National Committee on Uniform Traffic Control Devices

Attachment No. 7
Item No.: 18A-RW-01

NCUTCD Proposal for Changes to the Manual on Uniform Traffic Control Devices

TECHNICAL COMMITTEE:	Regulatory and Warning Signs Technical Committee
ITEM NUMBER:	18A-RW-01
TOPIC:	R1-5 Series Signs – Multi-lane use vs Single Lane Use
ORIGIN OF REQUEST:	RWSTC Task force. Tom Heydel RWSTC (chair), Scott Kuznicki, Ross Oyen, Charles Meyer
AFFECTED SECTIONS OF MUTCD:	Section 2B.11 (Yield Here to Pedestrians Signs and Stop Here For Pedestrian Signs (R1-5 series))

105 **Figure 2B-2 Unsignalized Pedestrian Crosswalk Signs**

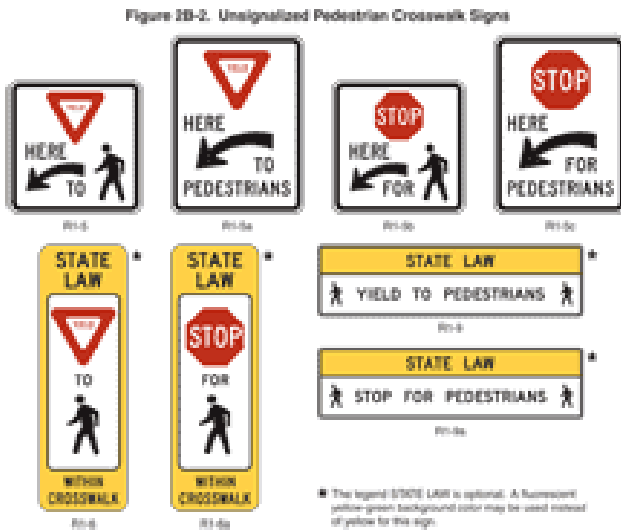
67 **Standard:**
68 **01 Yield Here To (Stop Here For) Pedestrians (R1-5, R1-5a, R1-5b, or R1-5c) signs (see**
69 **Figure 2B-2) shall be used if yield (stop) lines are used in advance of a marked crosswalk**
70 **that crosses an uncontrolled ~~multi-lane~~ approach. The Stop Here for Pedestrians signs shall**
71 **only be used where the law specifically requires that a driver must stop for a pedestrian in**
72 **a crosswalk. ~~The legend STATE LAW may be displayed at the top of the R1-5, R1-5a, R1-~~**
73 **~~5b, and R1-5c signs, if applicable.~~ (approved by Council 6-26-2014)**

74 *Guidance:*
75 *02 If yield (stop) lines and Yield Here To (Stop Here For) Pedestrians signs are used in*
76 *advance of a crosswalk that crosses an uncontrolled ~~multi-lane~~ approach, they should be placed*
77 *20 to 50 feet in advance of the nearest crosswalk line (see Section 3B.16 and Figure 3B-17), and*
78 *parking should be prohibited in the area between the yield (stop) line and the crosswalk.*

107 **Table 2B-1 – Add sign size for single lane for the R1-5, R1-5a, R1-5b, and R1-5c signs (36 x**
 108 **36)**
